Permitting decisions

Variation

We have decided to grant the variation for Vertellus Specialties UK Limited operated by Vertellus Specialties UK Limited.

The variation number is EPR/BU0311IX/V005.

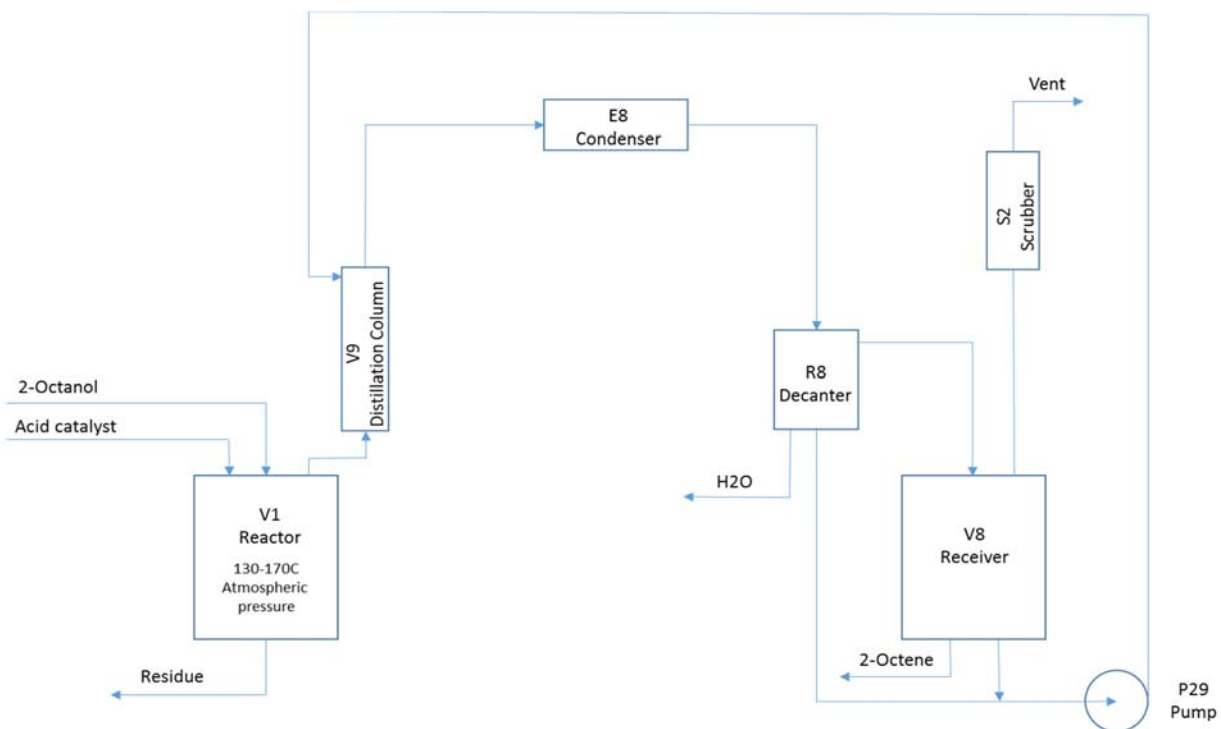
The caprylene process (as shown in the diagram below) utilises a glass-lined reactor vessel (V1), from which products can be distilled out by using a new distillation column (V9) and collected in a glass-lined receiver vessel (V8). The process is vented to atmosphere through the existing water scrubber (S2). Given the low vapour pressures of the materials being handled, the concentrations of potential pollutants in the air stream are very low. Since the materials themselves (volatile organic compounds [VOCs]) are largely insoluble in water, the main effect of the water scrubber is to cool the off-gases prior to discharge. This is also the case for the other organic chemicals produced in Plant 4 under the Multi-Product Protocol at other times.

The gaseous discharge from reactor 1 (V1) is routed in turn to the new distillation column (V9), to the condenser (E8), to the decanter (R8) and to the receiver (V8) before any gaseous carry over into the scrubber (S2) and eventual release to atmosphere via the existing vent. Recirculation of liquors is contained by a closed loop pumping return system to the distillation column (V9). The condensation process reduces and recycles the gaseous VOC loading at source and facilitates the transfer of potential pollutants from the waste gas phases into the liquid phase. The liquid phase effluent is not discharged directly from the site and is transferred to Northumbrian Water Bran Sands Water Treatment Facility by tanker, where it undergoes further treatment.
